SUBJECT: Approval of Reduced Quantity-Distance (QD) for the Air National Guard
Maintenance & Inspection Facility Standard Design

(b) U.S. Army Corps of Engineers, Engineering & Support Center Huntsville, Air
National Guard Maintenance and Inspection Facility Standard Design, Final
Design Submittal, Design Drawings and Design Narrative, 23 October 2024

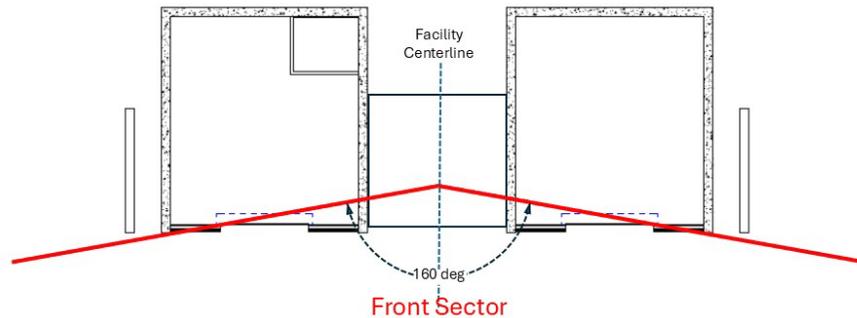
(1) The front side of the facility is defined as the 80-degree sector on
either side of the facility's centerline (160-degree combined angle, see graphic below), with the
vertex of the angle placed so that the sides of the angle pass through the intersection of the front

wall and side walls. This angle is based on lines of sight from worst-case explosives locations in the bays with 5-feet (ft) minimum standoff to the front wall.
